LR-N99320  
LCR S99-15

**REQUEST FOR ONE-TIME CHANGE TO TECHNICAL SPECIFICATIONS  
MOVABLE INCORE DETECTORS  
SALEM GENERATING STATION UNIT NO. 2  
FACILITY OPERATING LICENSE DPR-75  
DOCKET NO. 50-311**

**SALEM GENERATING STATION  
UNIT NO. 2  
FACILITY OPERATING LICENSE DPR – 75  
DOCKET NO. 50-311  
CHANGE TO TECHNICAL SPECIFICATIONS  
MOVABLE INCORE DETECTORS**

Figure 1

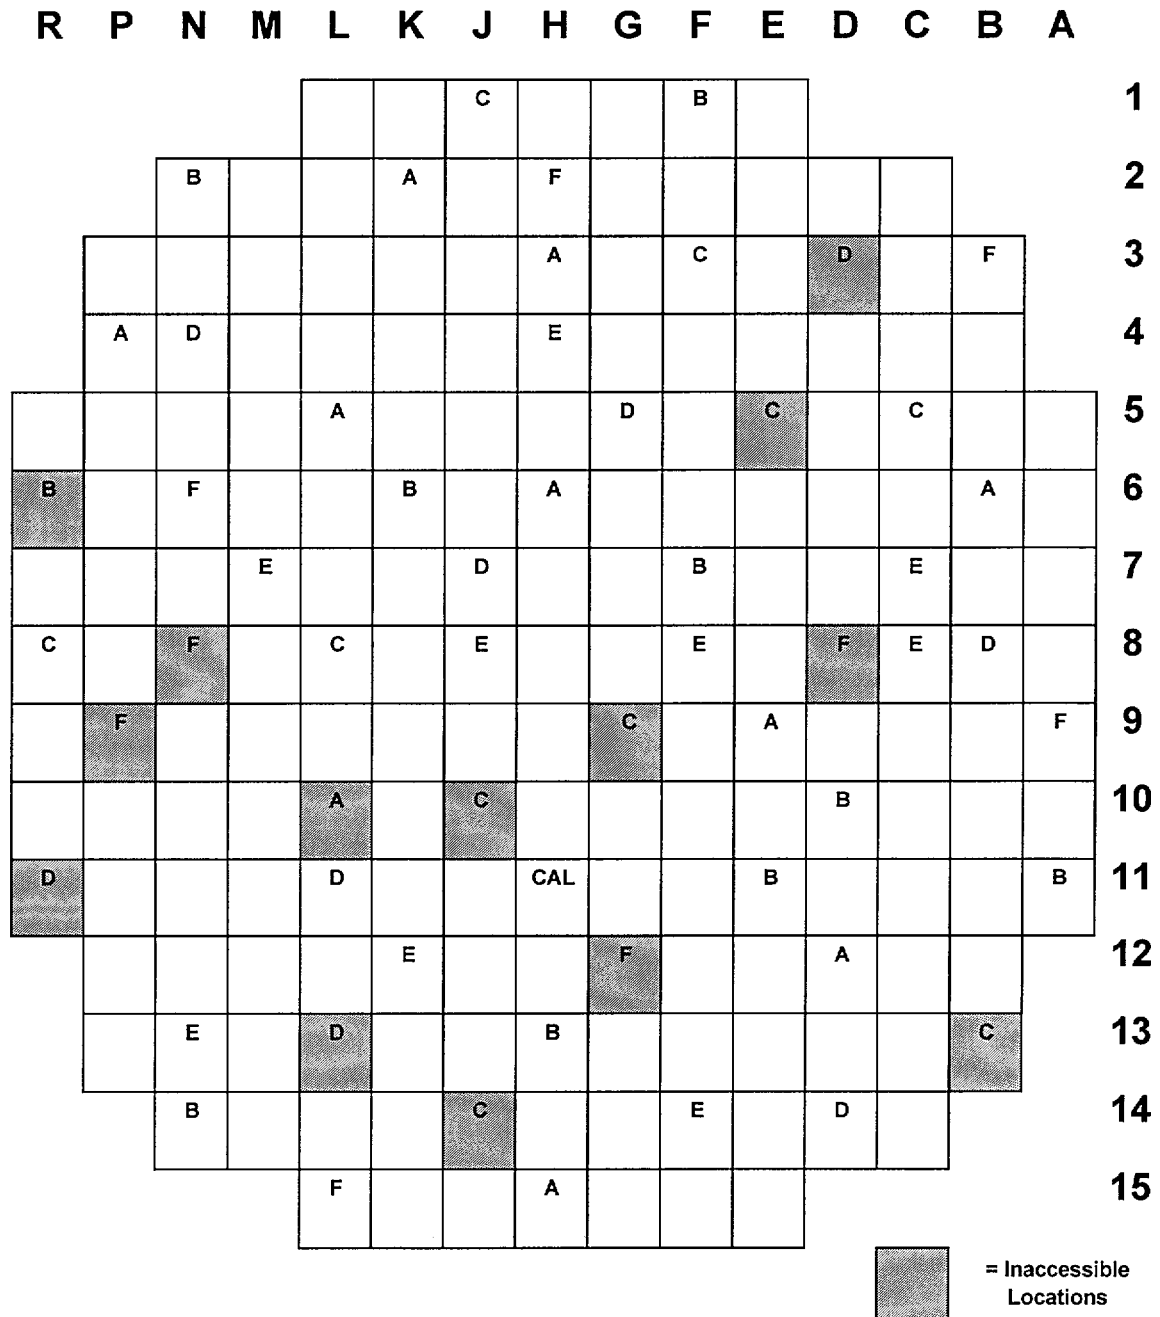
During the flux map performed on March 27, 2000, 75.8%% (44 of 58) of the incore thimbles would allow passage of the movable detectors. Figure 1 shows the thimble locations inaccessible during the performance of flux map 14 for Unit 2 Cycle 11. The number of available locations has changed throughout Unit 2 Cycle 11. However, as can be seen in Figure 1, the available thimbles were well distributed throughout the core and thimble coverage was adequate.

While Figure 1 shows a large number of the inaccessible thimbles located in a single quadrant (quadrant IV), the remaining accessible locations satisfy the criterion for random thimble deletion. Our analysis of the failed locations indicates there is no systematic failure mode associated with a particular quadrant.

In addition to the uncertainty changes, the Westinghouse evaluation also specifies that whenever greater than or equal to 50% and less than 75% of the detector thimbles are available, there should be a minimum of four thimbles available per quadrant, where quadrant includes both horizontal-vertical quadrants and diagonally bounded quadrants (eight individual quadrants in total). This requirement improves the ability to distinguish between random and systematic thimble deletion events and establishes the bounds of applicability of the peaking factor uncertainties. The peaking factor measurement uncertainty analysis in the Westinghouse evaluation makes the assumption that thimbles were randomly deleted from the core. If the thimbles are somehow systematically deleted from use, then the calculated peaking factor measurement uncertainties will not apply. TS 3.3.3.2.b requires a minimum of two detector thimbles per quadrant. However, the current requirement is not sufficient to distinguish between random and systematic deletion events with high confidence. To ensure that thimble deletion is random, a footnote would be added to Technical Specification 3.3.3.2.b to provide the more restrictive quadrant requirements necessary for Unit 2 Cycle 11 with greater than or equal to 50% and less than 75% detector thimbles available. This footnote will establish the bounds on the number of detector thimbles per quadrant to be consistent with the Westinghouse evaluations and will significantly enhance the ability to distinguish between random and systematic events.
